Service Bulletin

Bulletin No.: PI1382

Subject: Intermittent Unable to Charge from DC Fast Charge

Models: 2014-2015 Spark EV
Equipped with PROVISIONS-FAST CHARGING ACCOMMODATIONS (RPO CBT)

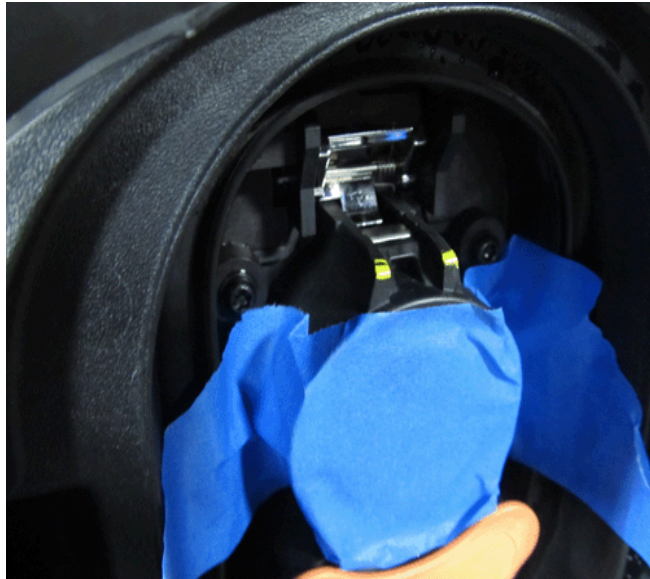
Some customers may comment on the vehicle not charging when using a DC fast charge coupler, or that the coupler had to be reinserted or "jiggled" before a charge was initiated.

This condition may be caused by interference between the DC fast charge coupler and the vehicle charge port receptacle. The presence and severity of the concern can vary between DC fast charge stations.

4037063

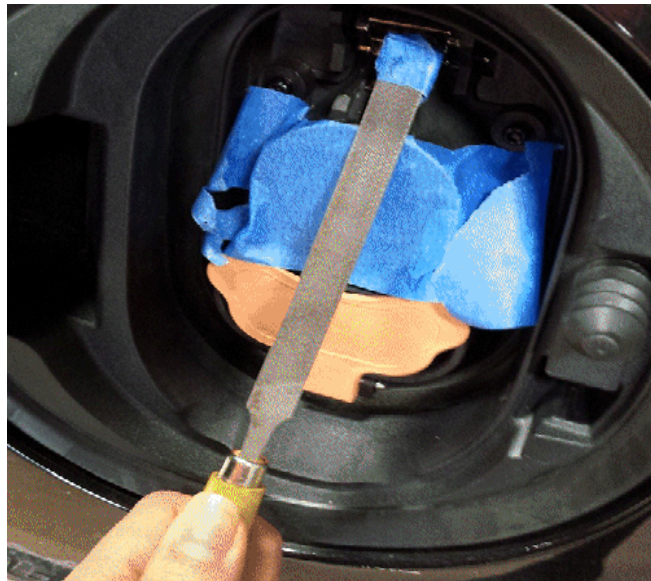
Note: Upper receptacle guides are marked in yellow for illustration purposes only.

3. Starting at point "1" as shown above, measure 6 mm to point "2" and 3 mm to point "4." The material above that mark (shown in red above) will be the material removed. Repeat on second receptacle guide.

Important: It is important to follow the dimensions as given above to ensure the interference concern is addressed.
